SDIS1 HW Change Document

Product: SDIS1
Author: Vivian Kill-Tollnek, Emil Schuster, Tobias Cremer
Approver: CTC Advanced
Date: 28.09.2016
Version: v2.3
Status: Draft
Location: P:\SDIS1\05_SW08_Certification\TCF

1 Introduction of HW42

Figure 16 Voltage undershoot correction: change in schematics

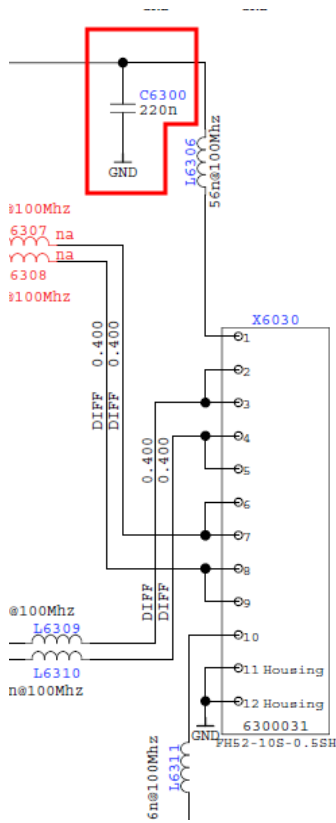
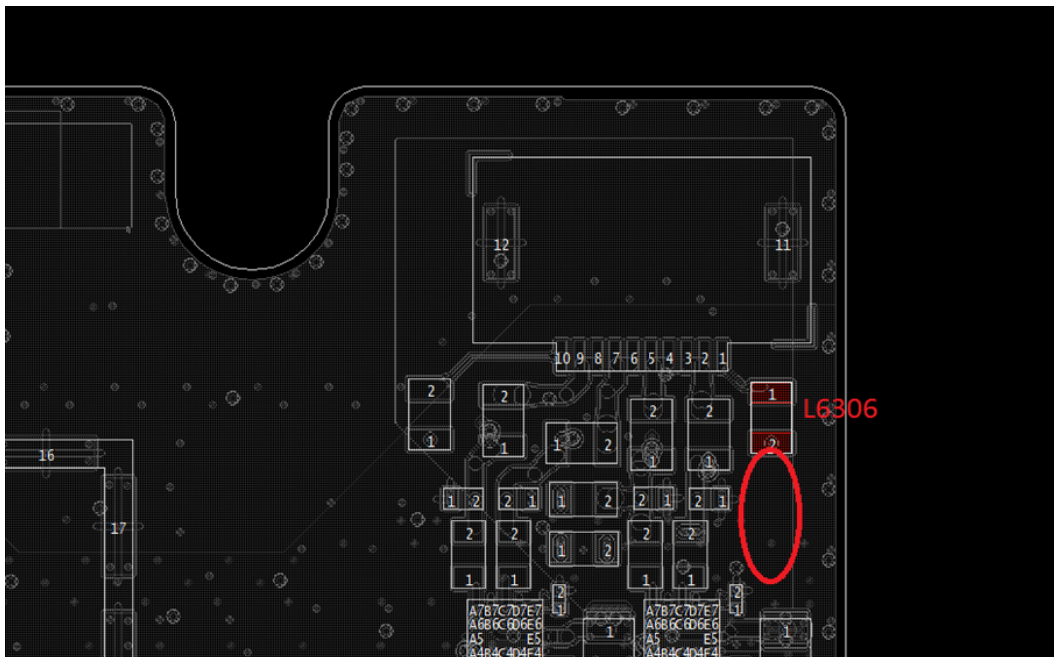
Current circuitry creates unwanted voltage-undershoot, which is not allowed (could harm application processor)
 Solution: Implementation of one additional capacitors on engine PWB.

Figure 19 changed schematics for PMIC HW shutdown

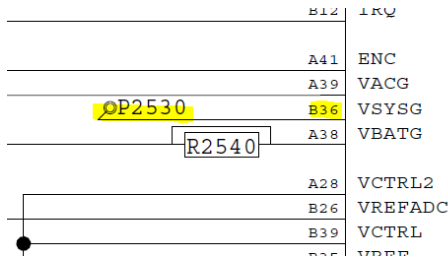
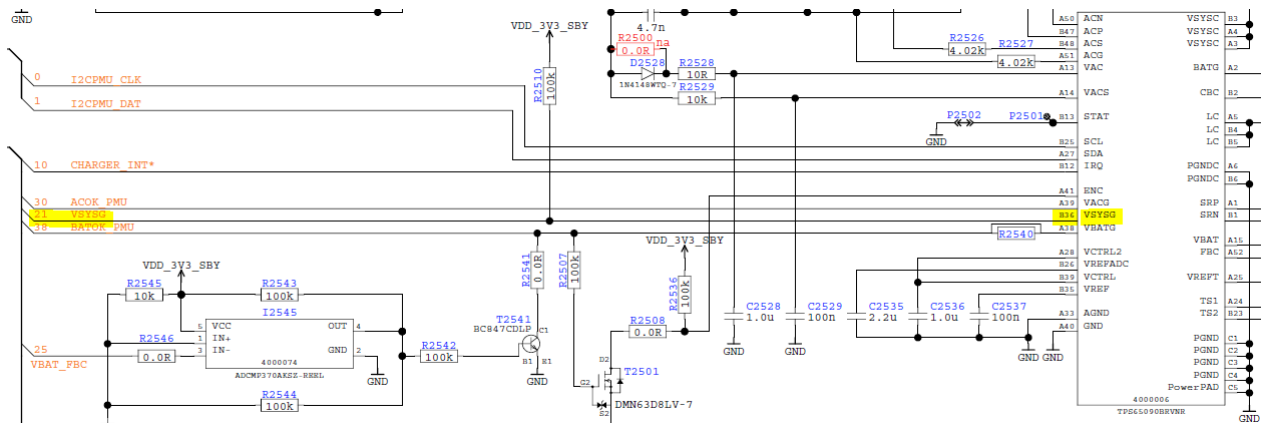
In case of unexpected system-power-cut to PMIC, the component must be shutdown via HW trigger (NSLEEP), to prevent potential damage of the component.

Figure 21 Schematics after change

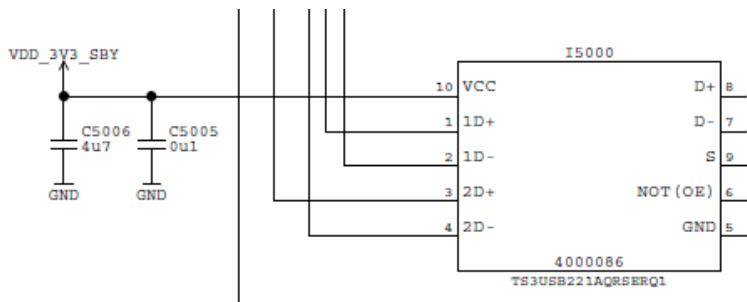
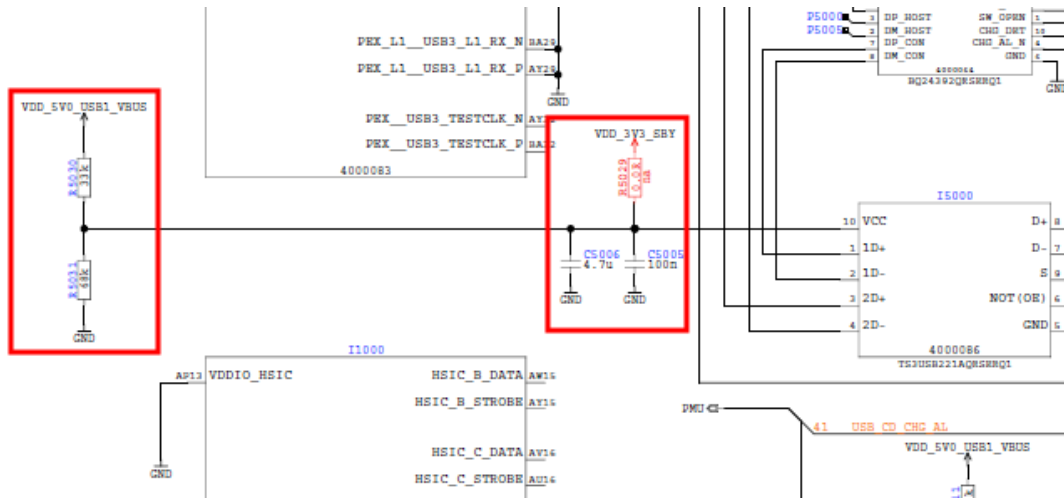
Power supply for USB-Mux (I5000) needs to be re-assigned from VDD_3V3_SBY to VDD_5V_USB1_VBUS, correct supply voltage needs to be set by resistive voltage-divider and one zener-diode.

Figure 23 Schematics after change

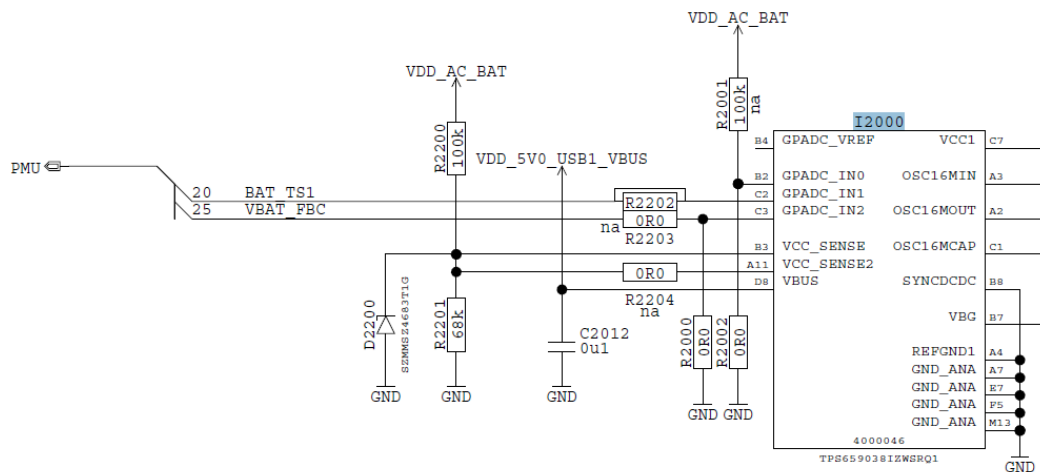
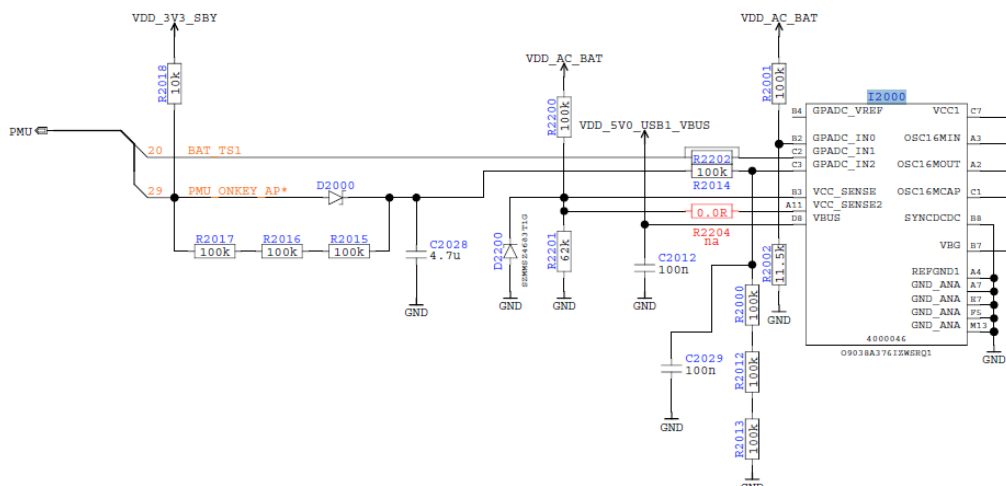
Wilink8 needs to be forced to shut-down (WL_EN and BT_EN pulled low by HW-Circuitry), in case of unexpected power-cut.

Figure 24 Changed schematics for UART4 option

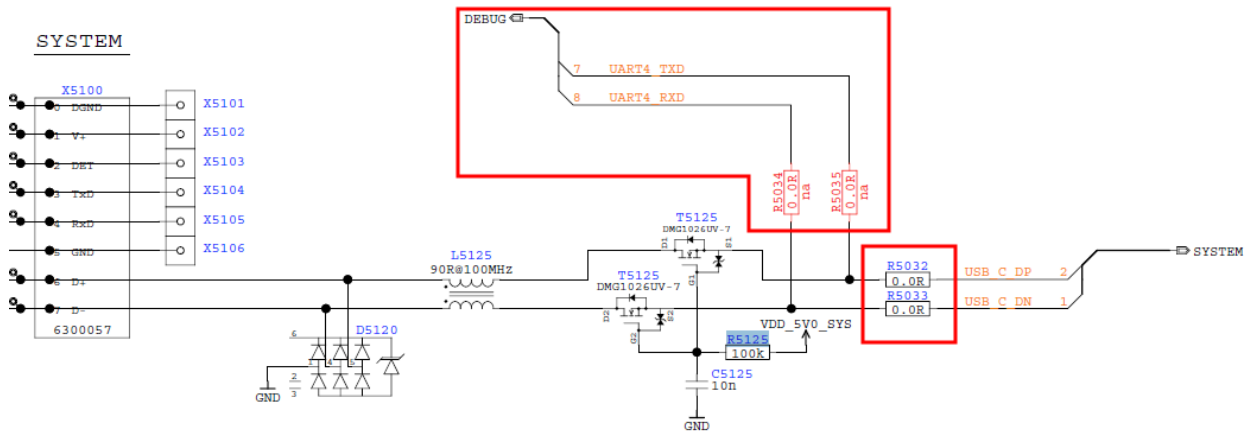
2 additional resistors 0201 0R0 Ohm Rohm MCR006YZPJ000

Figure 26 Detailed schematics after change

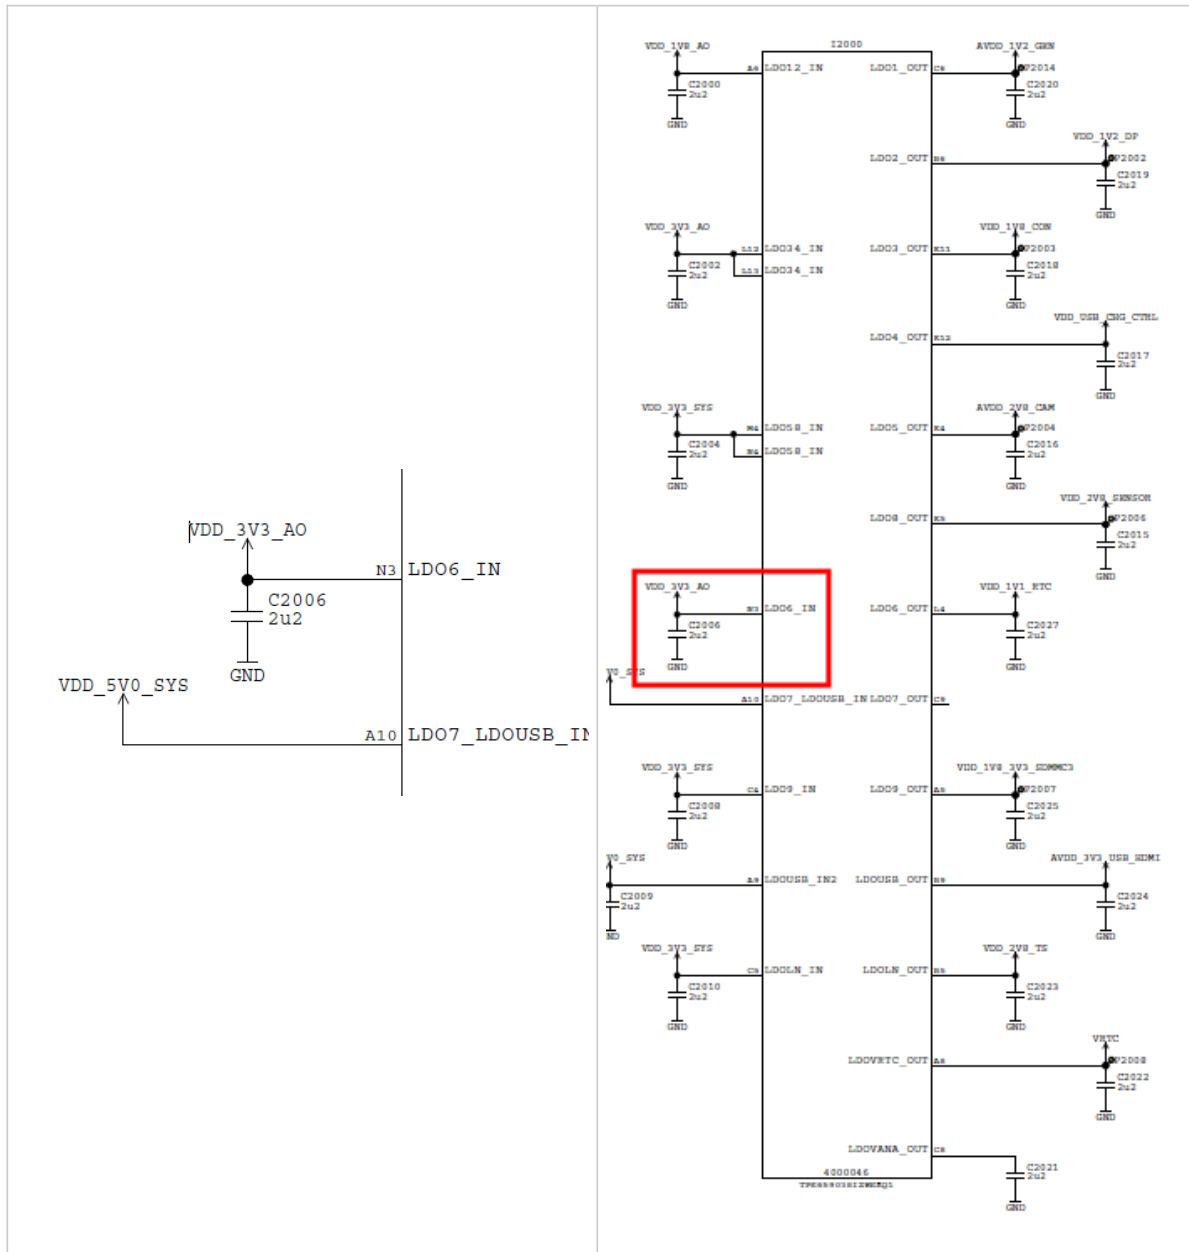
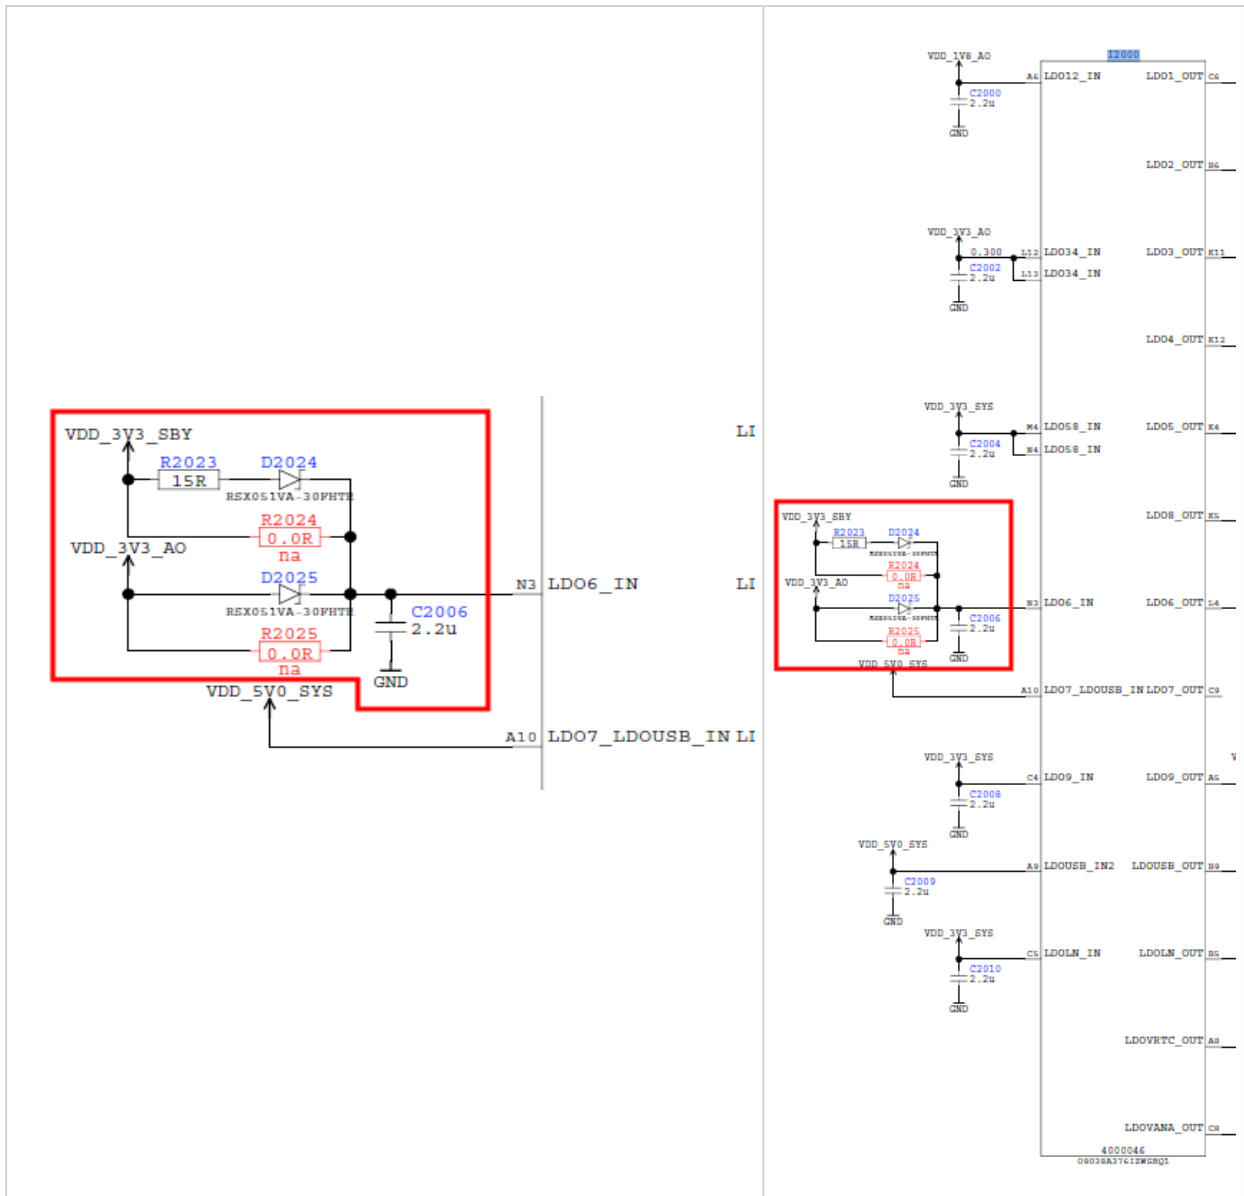
Power sequence for LDO6 input needs to be modified, in order to prevent PMIC deadlock under rare condition.

Figure 28 Schematics after change

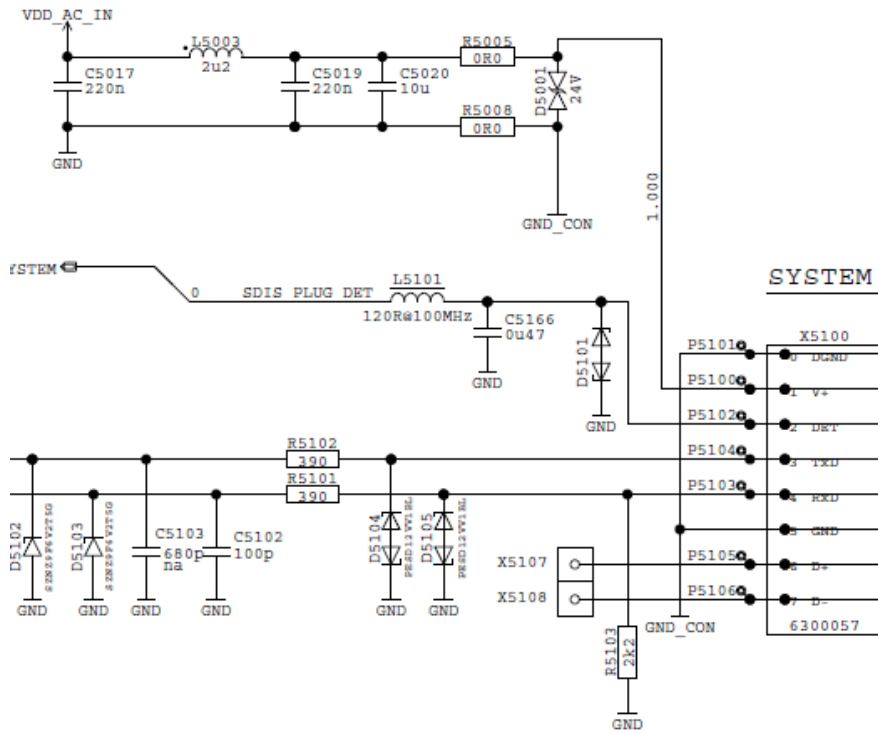
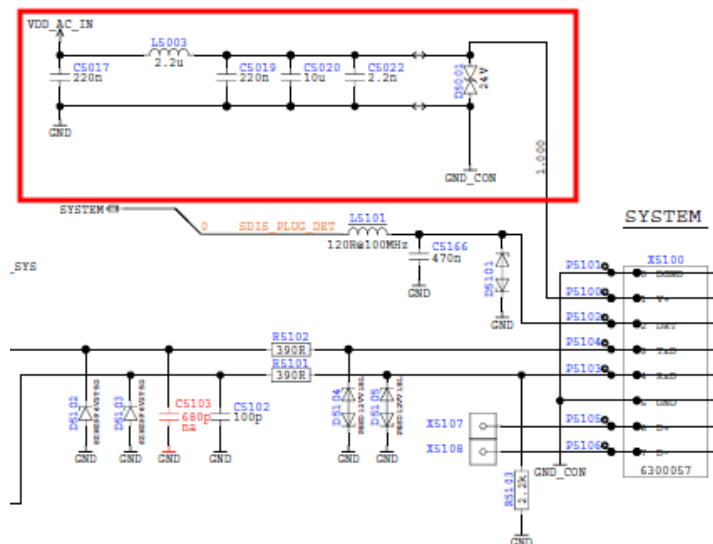
Changes to Engine PCB required to add a 2n2 50V 0603 capacitor to the V+ Supply close to the system connector. Removal of 0 Ohm Resistors in Supply Lines.

Figure 30 Schematics after change

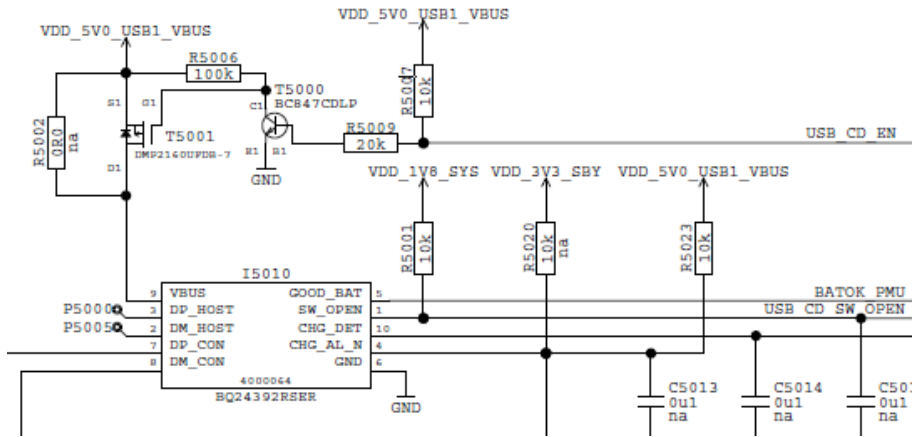
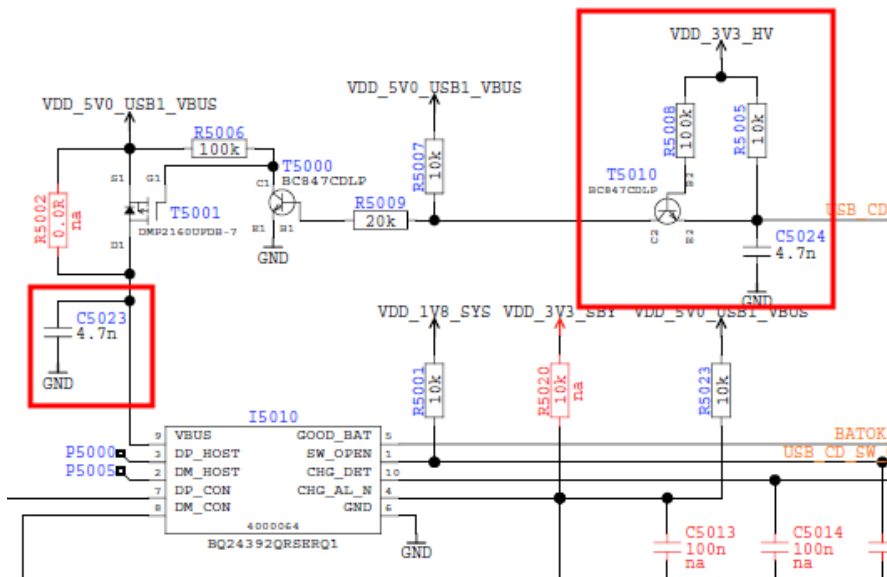
Update for PCB and components. in order to avoid non-deterministic behaviors of GPIOs after boot up and damage of VCM after ~60k boot cycles.

Figure 31 Comparison of schematics

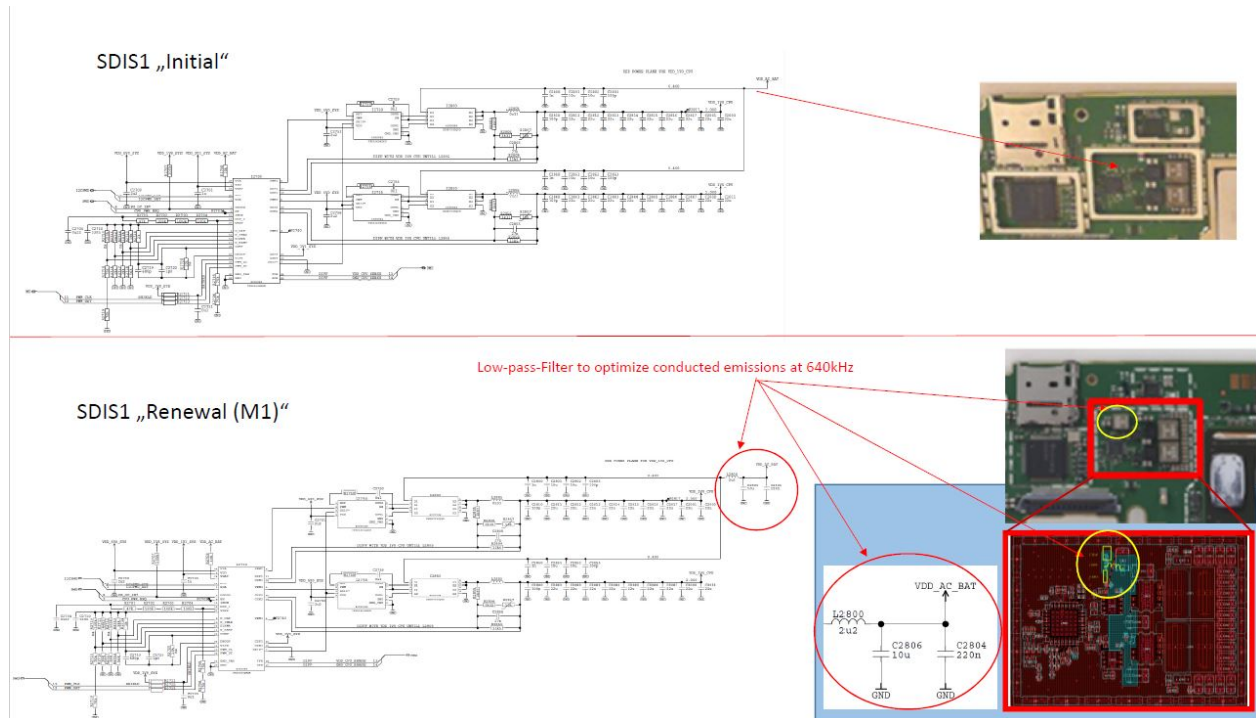
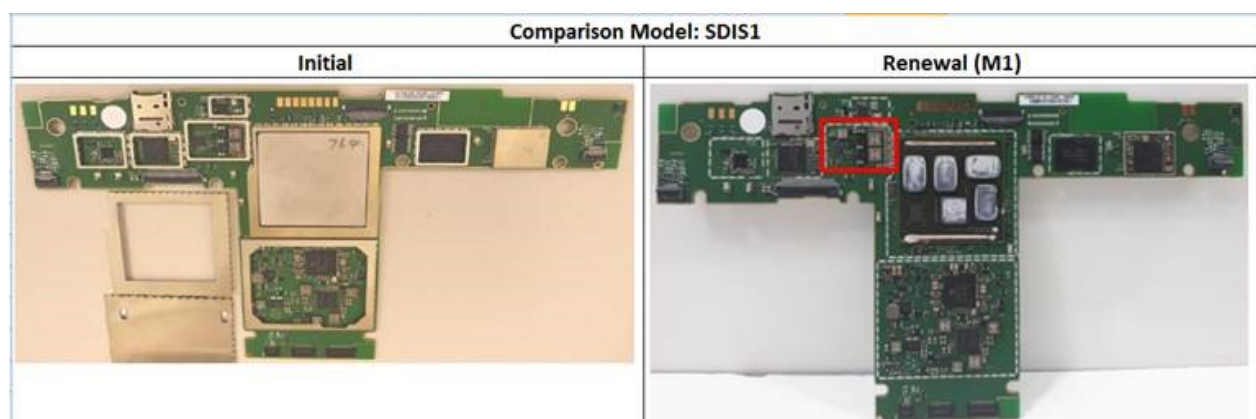
1. The modifications shown in “M1” are incorporating a low-pass-filter, in order to optimize the conducted emissions behavior at 640 kHz
2. The low pass filter is comprising
 - a. Shielded power inductor: Coilcraft XAL4020-222ME 2.2.uH
 - b. Capacitor: Murata GCM188R71E224KA55D 220nF
 - c. Capacitor: Murata GRM21BC81E106KE11 10uF
3. The SDIS1 passed official testing at CETECOM including this low-pass-filter

Figure 34 Schematics of Thermal Display after change

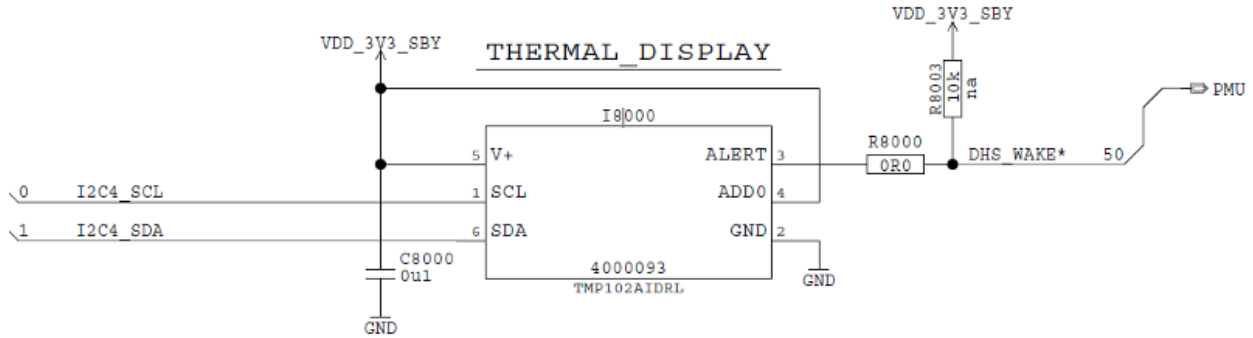
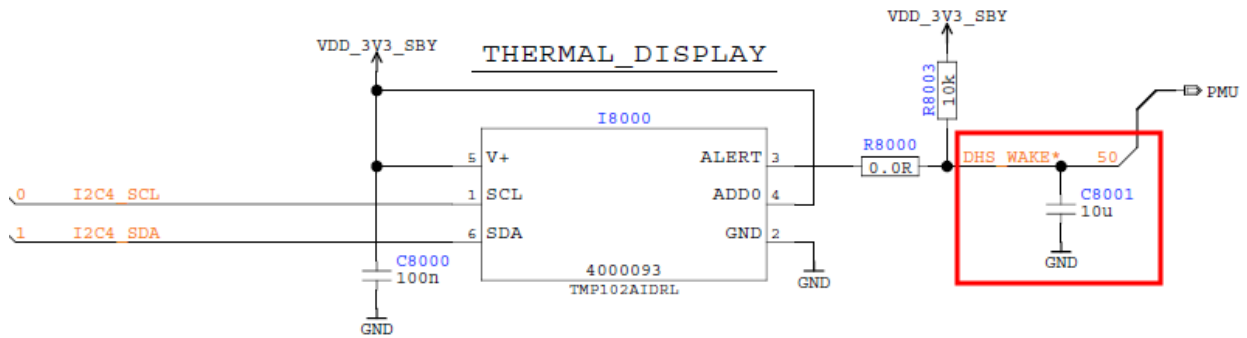
Added a capacitor on the DHS_WAKE*.

Component: Capacitor 0603 10u +/-20 % 10Vdc, Murata, GRM188C81A106MA73

Reason: Wake-up the system when battery power comes back with temperature decreasing after interruption at 80°C, so that TMP102 can be reconfigured via software after POR.
